**UNITED STATES DEPARTMENT OF COMMERCE  
Patent and Trademark Office**

APPLICATION NO.	FILING DATE	FIRST NAMED INVENTOR	ATTORNEY DOCKET NO.
09/214,519	01/07/99	HASHIZUME	T 101850

# Office Action Summary

Application No.  
09/214,519

FIG. 5

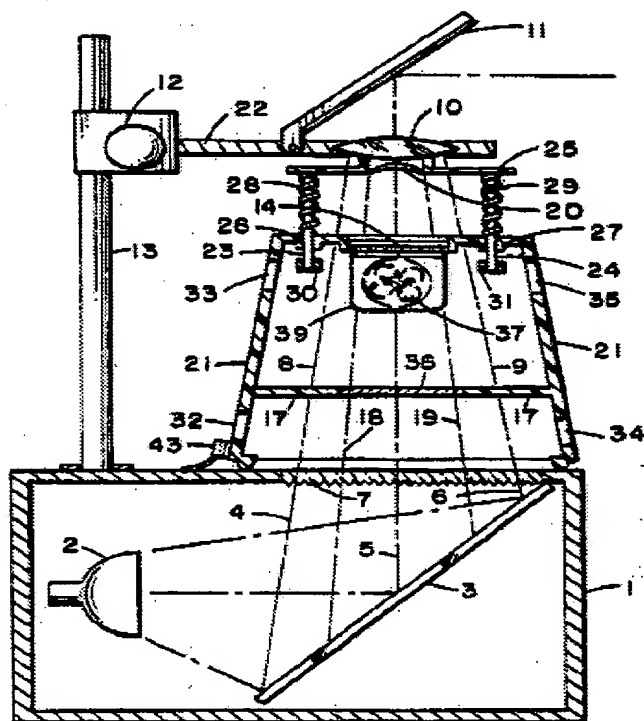
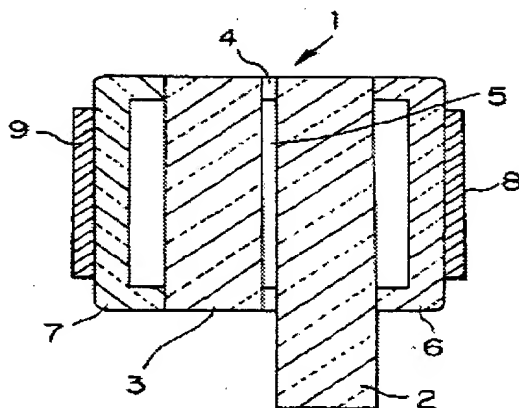
Regarding claims 1 and 4 (amended), Yamada et al. disclose .....an optical modulation element[Fig 5, #5] ..... a transparent plate [Fig 5, #3] secured to the optical modulator ..... a projection unit [Fig.2, #209].

Regarding claims 2 and 9 (amended), Yamada et al. disclose .....a polarizer [Fig 5, #9] bonded to the transparent plate.

Regarding claim 6 (amended), Yamada et al. disclose the transparent plate [Fig 5, #3] thickness is larger than the focal length of the projection lens [Fig 2, #209].

Regarding claim 8 (amended), as best the examiner is able to ascertain, Yamada et al disclose a polarizer [Fig 5, #9] and a pair of substrates [Fig 5, #2 and #3]
